APPLICATION NO.	FILING DATE	FIRST NAMED INVENTOR	ATTORNEY DOCKET NO.	CONFIRMATION NO.
09/775,677	02/05/2001	Jan Otto Solem	JM-050 CIP	3473

Office Action Summary

**Fig. 19*****Claim Rejections - 35 USC § 103***

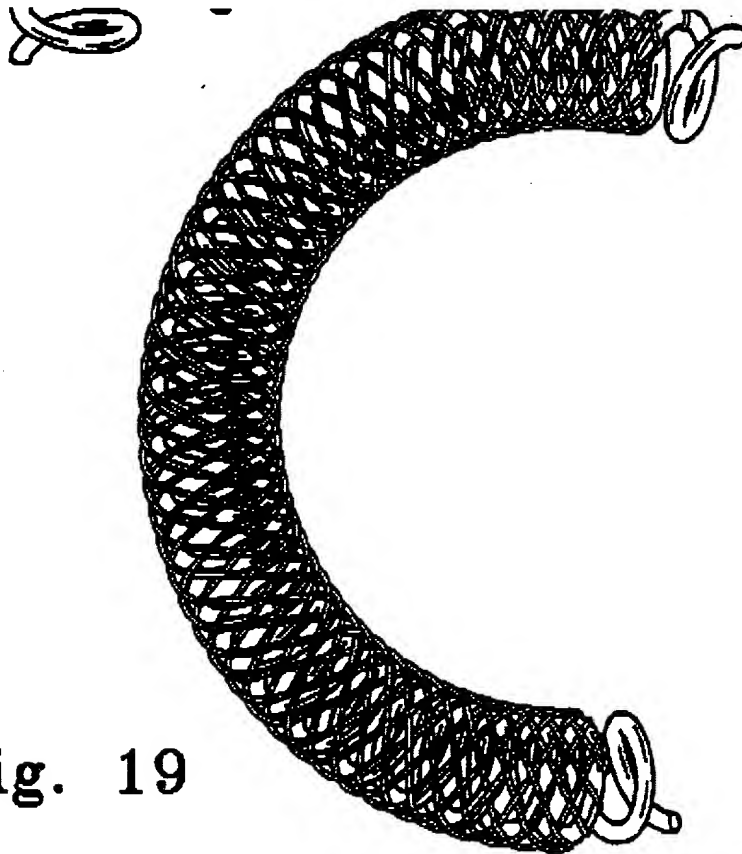
Claims 14, 17 and 89 are rejected under 35 U.S.C. 102(b) as being anticipated by Phelps et al [5382259].

Phelps et al discloses a medical comprising an elongate body adapted to be fixed to a vessel, the elongate body extending between a proximal end and a distal end, and that is adjustable from a first configuration having a first shape such that the

elongate body is adapted to be delivered at least in part into the vessel to a second configuration having a second shape such that the elongate body is capable to exert a force from within the vessel onto the tissue that would remodel the shape of the extravascular tissue. See figure 19.

With respect to claims 14 and 89, although Phelps, et al does not disclose use of the stent within the coronary sinus, the stent is structurally capable of being used therein.
